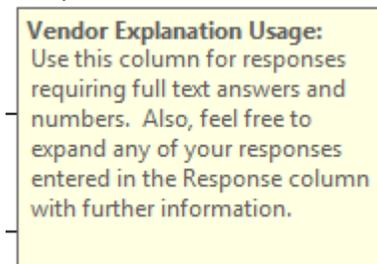
33. In at least one place in the CMMS tab (e.g. Rows 93, 118), when the proposer hovers over Column C, it says:

However, when the proposer hovers over the corresponding cell in Column G "Vendor Explanations," the following note appears:

Vendor Explanation Usage:
Do NOT use. Your response(s) must be in the RESPONSE and ENHANCEMENT COST columns as appropriate.

Should we assume Column C ("use 'Vendor Explanations'") overrides Column G ('use "Response") in these cases?

[That was a mistake on our part, please use the Vendor Explanations column wherever you need/want to add an explanation.](#)
